Screening Attn. Clauses for –V1 191.10.1.5 and 192.8.1.5

Contribution to IEEE 802.3dm, Ad Hoc Jun-16 2026

Scope

Figure 192-43—V1 link segment screening attenuation

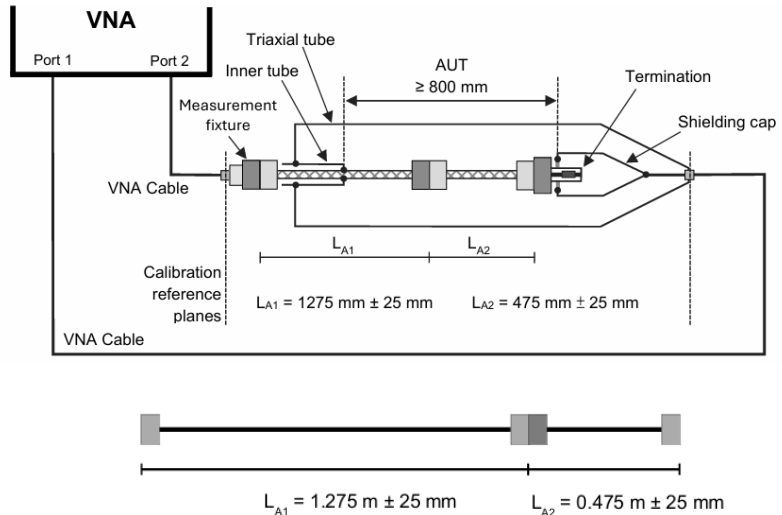
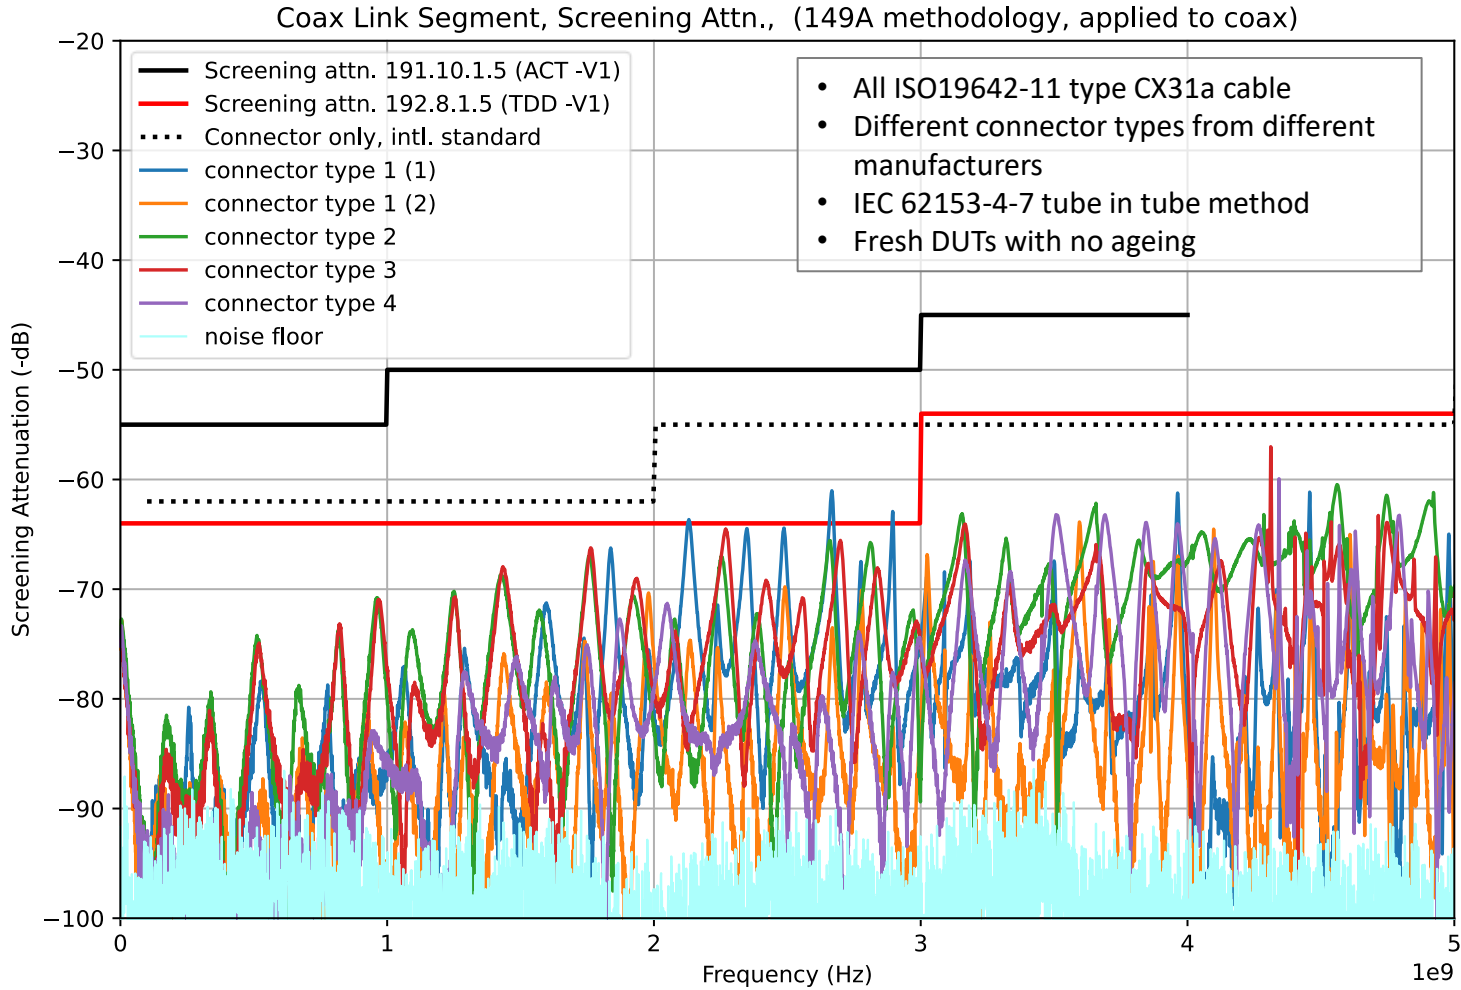
192.8.1.5 requirement for complete link segment more severe than requirement for a single automotive coax connector. Thus, the 802.3dm objective "Define ... link segments suitable for use with ... automotive unbalanced coaxial cabling supporting use of up to 4 inline connectors ..." cannot be fulfilled. → Propose same requirement as for 191.10.1.5

- Change requirement for clause 192.8.1.5 to be the same as for clause 191.10.1.5
- Delete reference to ISO 19642-11
- Mention that the 149A methods need to be adapted to unbalanced coaxial cabling.

The screening attenuation of a –V1 link segment shall meet the values determined using Equation (191-19). Screening attenuation is tested as specified in IEC 62153-4-7 using triaxial tube-in-tube method. Additional screening attenuation test methodologies are defined in Annex 149A. These methodologies shall be applied with adaptation to unbalanced coaxial cabling and shall use a single 50 Ω termination to ground.

Figure 149A-2—Coupling attenuation reference cable assembly measurement setup

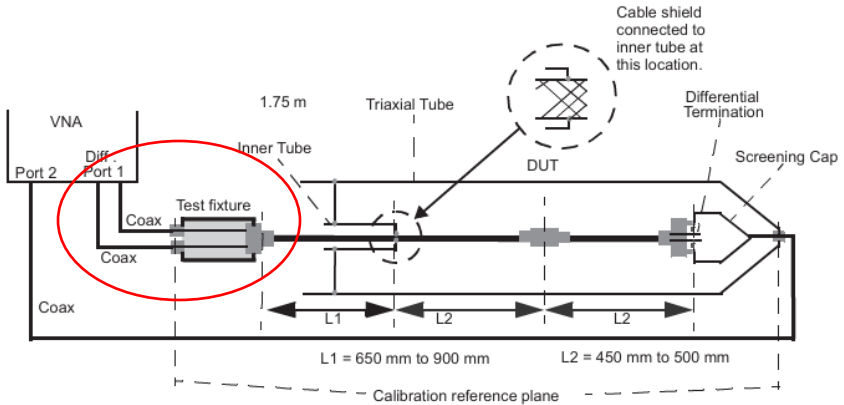
- Clause 149A specifically describes balanced pair only – see red marked sentences in the screen shot.
- This may cause confusion or miss-interpretation

Proposal: Change sentences in line 33 on page 147 and in lines 4-5 on page 239 as follows explaining, that the method in 149A shall be used in general but has to be applied to coaxial cabling:

“Additional screening attenuation test methodologies are defined in Annex 149A. These methodologies shall be applied with adaptation to unbalanced coaxial cabling and shall use a single 50 Ω termination to ground.”
